MEMORANDUM

DATE: September 22, 2003
TO: Montgomery County Planning Board
VIA: Joseph R. Davis, Chief
Michael Ma, Supervisor *Ma*
Development Review Division
FROM: Mary Beth O'Quinn *MBO*
Planning Department Staff
(301) 495-1322

REVIEW TYPE: Site Plan Review
APPLYING FOR: Approval of a total of 199,529 square feet of commercial space for retail use, of which 26,015 square feet is new additional retail space and 61,206 square feet is partial re-development of the existing retail space of 173,514 square feet

PROJECT NAME: Germantown Commons
CASE #: 8-85066A
REVIEW BASIS: Site Plan required in the Town Sector Zone [§59-C-7.21]
Waiver to allow Building Construction across a Lot Line [§59-C-7.28(d)]
Approval of Off-Site Parking [§59-E-3.4]

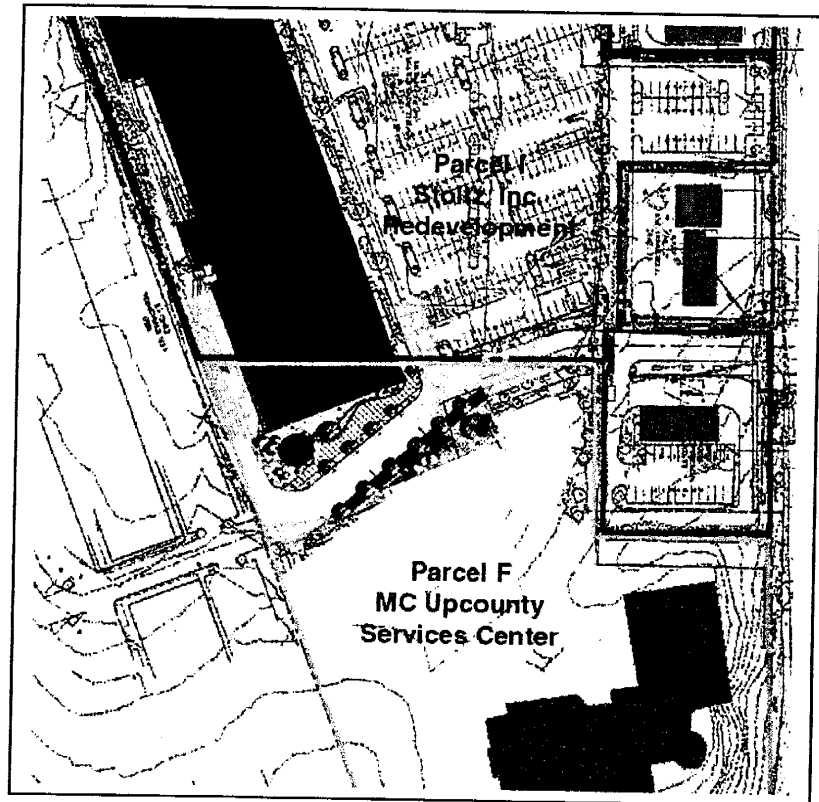
1. Waiver to allow Building Construction across a Lot Line [§59-C-7.28(d)]
The applicant requests a waiver per Montgomery County Code, §50-20(b) of the Subdivision Regulations to allow construction of the southwest portion of the proposed retail building on Parcel I to encroach onto Parcel F, the adjoining property to the south. This adjoining parcel is owned by Montgomery County and is currently occupied by the Upcounty Regional Services Center. The proposed plan features a building area of 8,379 square feet occupying land area across the lot line. It should be noted that the Planning Board, under the existing Site Plan (8-85066), approved August 8, 1985, granted a waiver for same area, currently subject to an easement recorded in the land records of the county.

The Montgomery County Zoning Ordinance, §59-C-7.28(d), allows the Planning Board, during the course of Site Plan Review, to waive substantive requirements of the Subdivision Regulations upon a finding that the waiver would allow “greater flexibility of development consistent with the purposes of the zone and promote more attractive and efficient overall planning and design.”

Staff recommends approval of the waiver for the following reasons:

- The continuous line of storefronts featuring a unified architectural treatment, along with upgraded pedestrian sidewalks will provide an uninterrupted streetscape that is safer and more efficient and contributes more efficient use of the site in its planning and design;

- The building line established (and footprint, thereof, that crosses the lot line) reinforces the new street alignment proposed with this site plan, hence creating greater efficiency for the movement of vehicles and pedestrians;

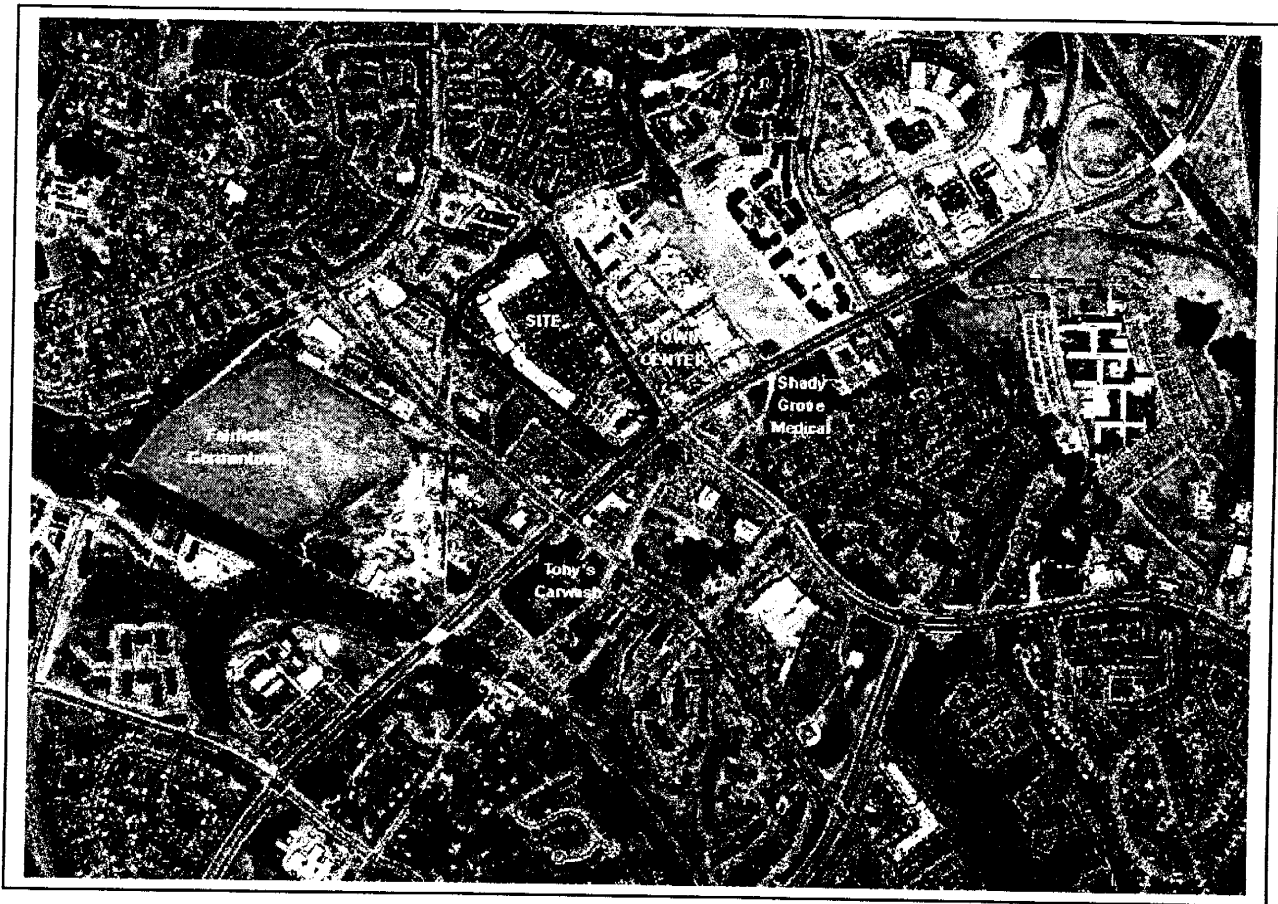
Staff Position: Staff recommends that the full Town Center Streetscape be provided according to the *Guidelines*, as currently installed for all other areas of the Town Center, including street trees, areas of paving, including pedestrian crosswalks and street lighting. Additionally, the amenity seating areas must be incorporated into the design using the approved streetscape elements to provide a unified design appearance that will knit together the varied retail uses and storefronts that characterize this shopping center.

Staff does not support the single request for the construction of Locbury Drive as a requirement of this Site Plan since the plan, as proposed, since the existing five access points provide adequate, safe access. Furthermore, the proposed addition of 26,015 square feet does not require additional public road access.
